NASA Engineering and Safety Center Consultation Position Paper	Document #: RP-04-08	Version #: 0.01
Title: Technical Consultation of the Hubble Space Telescope (HST) Nickel Hydrogen (NiH₂) Battery Charge Capacity Prediction			Page #: 1 of 49

**Technical Consultation
of the
Hubble Space Telescope (HST)
Nickel Hydrogen (NiH₂) Battery Charge Capacity Prediction**

A multi-Center and industry review team of knowledgeable Nickel Hydrogen (NiH₂) battery specialists was convened to assess the Goddard Space Flight Center (GSFC) position paper entitled, “The State of the HST Batteries as it Relates to HST Health, Safety, and Ability to Support an On-going Science Operation”, dated May 21, 2004 (provided in Appendix D) [ref. 1]. This document was prepared by Dr. J. Keith Kalinowski, Deputy Manager, Hubble Space Telescope (HST) Operations Project, with planned approval by Preston M. Burch, Manager, HST Program Office. The document review was supplemented with extensive technical discussions with the position paper author, pertinent reports from literature, NASA-sponsored Aerospace Battery Workshops, and consultations with team peers.

Figure 2.3-1. Typical Plot of Correlation between Battery Voltage (at 9 Ah load) and Cell Capacity at 1.2 V

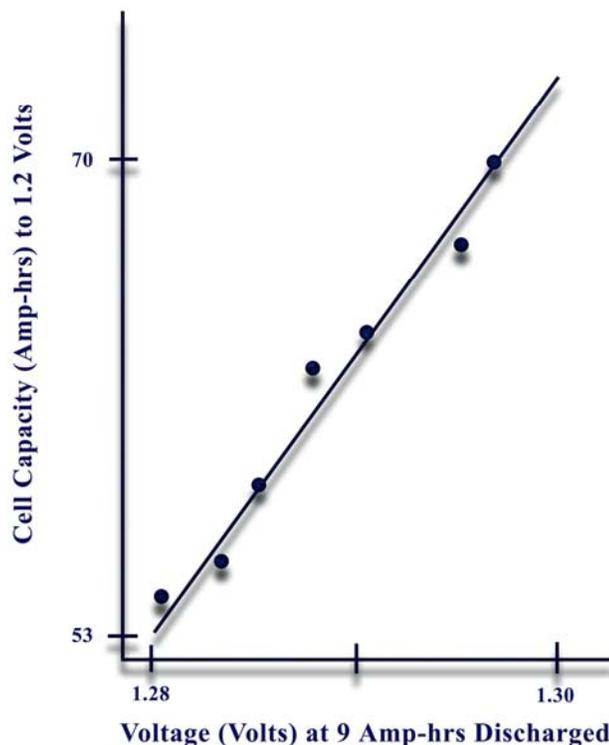
- 2.3. Determine if a proportional correlation exists between the voltages in the test battery discharge at the 9 Ah point and the measured capacity to 1.2 V for each cell (Figure 2.3-1).

Correlations between NiH₂ cell or battery voltage and the amount of stored capacity have often been found to be confounded by all the other variables that influence voltage, but not capacity. Such variables include current, temperature, and the past history of charge, discharge, as well as the SOC.

Discussions concerning the FSB testing, where the voltages of all cells are measured, have sometimes equated cell voltage divergence during cycling to capacity divergence. Establishing a correlation between the amount of stored capacity and the cell voltage at the end of the 9 to 10% DOD orbital cycle would provide a simple, real-time diagnostic tool to monitor the evolution of cell imbalance during cycling. This correlation could be checked (or recalibrated) each time the test battery is subjected to a capacity test. Such a correlation would plot the voltage of each cell at the DOD corresponding to orbital cycling (~10% DOD) during the capacity discharge against the capacity measured for that cell to 1.2 V. If a good correlation is in fact found to exist, cell voltage dispersion at the end of each orbital cycle can be used to accurately indicate relative shifts in cell capacities, and thus capacity imbalance. If a good correlation is not established, cell voltage divergence should not necessarily be used as a meaningful measure of capacity imbalance.

For HST batteries, where individual cell voltages are not available, this tool may help quantify how shifts in battery voltage during eclipse operation or capacity testing could translate into capacity loss or capacity divergence.

Figure 3.3-1. Ratchet Charging for Nominal On-orbit Cycling Operations

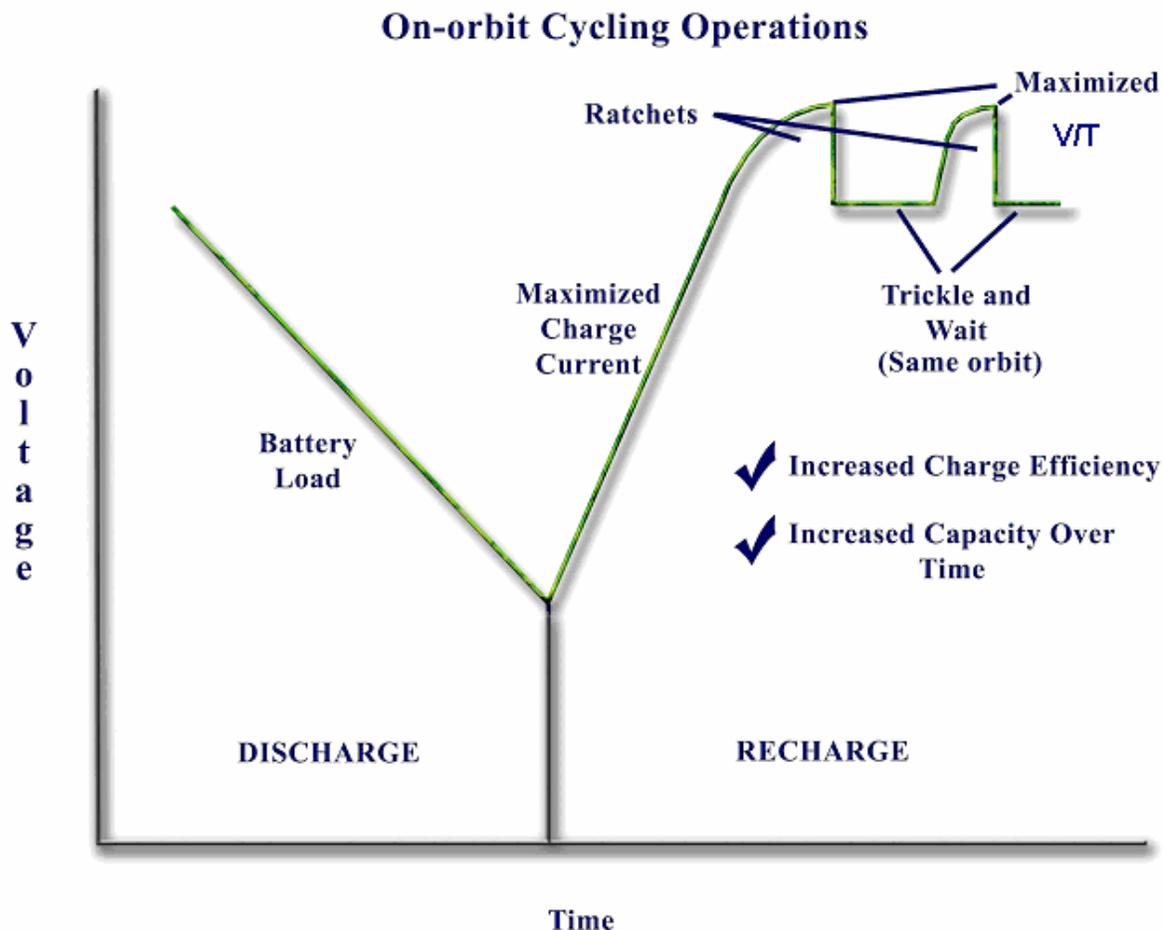
- 3.3. Investigate ratchet charging:

After the first ratchet to the voltage cutoff, then trickle charge mode and wait for recovery (10 to 20 minutes) and ratchet again.

- On-orbital cycling operations (Figure 3.3-1)
- Ratchet charging following capacity check (Figure 3.3-2)

Ratchet charging involves recharge to a V/T level or other charge cutoff criterion at a high charge rate, followed by a period of rest (typically trickle charge or open circuit), then a repeated recharge at the high rate to the same V/T cutoff level. If time permits, this high rate recharge and rest period can be repeated multiple times to ratchet the state of charge to higher levels (in LEO there may only be time for one ratchet). The overall RCF is intended to be similar to that with no ratchet recharge. However, three factors provide higher charge efficiency with the ratchet pulse-recharge sequence when the peak recharge rate is maximized. First, the lower recharge voltage that results from the rest period provides improved charge efficiency. Second, the trickle charge is more efficient when performed at a lower average state of charge. Third, charge efficiency always tends to be greater at higher recharge current.

Figure 3.3-2. Ratchet Charging following Capacity Test

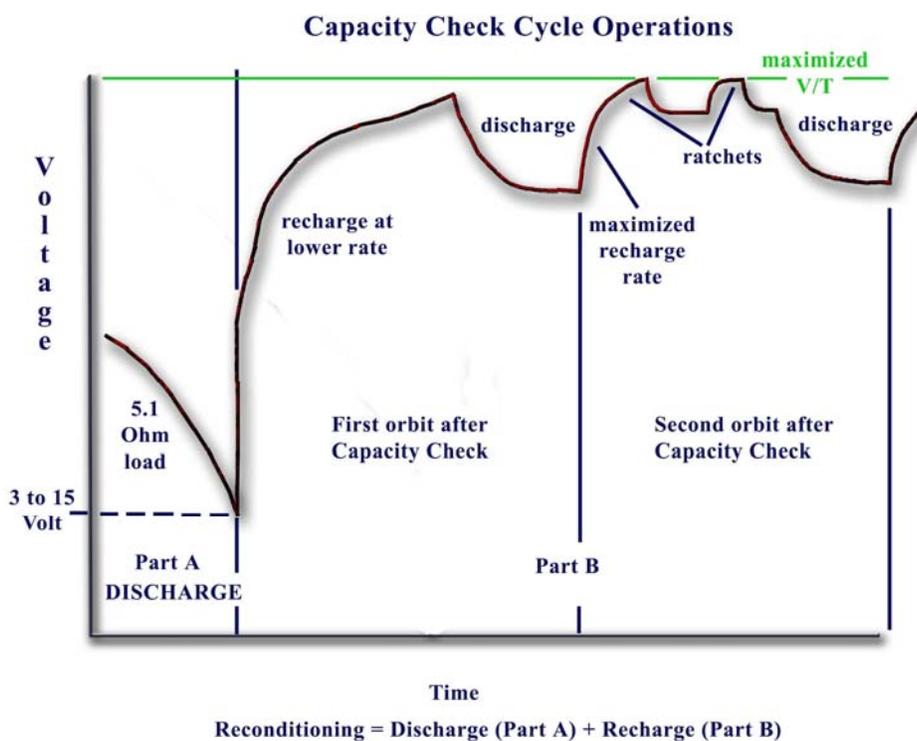
This charge control method is particularly advantageous when recharge to the V/T cutoff at high rate occurs in a short period of time. Application of much of the trickle charge during the middle portion of the recharge period takes maximum advantage of the higher charge efficiency for trickle charge at lower SOC. The second high rate recharge pulse will provide an SOC boost due to the improved charge efficiency at the high recharge rate. Repeated recharge pulses with adequate rest between can ratchet the SOC up significantly.

This type of recharge profile should be evaluated to determine whether it is possible with the HST charge control hardware/software. This recharge method is expected to particularly benefit the recharge of a newly capacity tested battery, since it should allow a higher fraction of the returned charge to occur at the high rate. This charge method is not expected to have deleterious thermal effects if the total RCF is maintained to be similar to the RCF without ratchet charging. The average heat produced by the batteries can be limited to 30 W by appropriate adjustment of the software V/T levels for each battery.
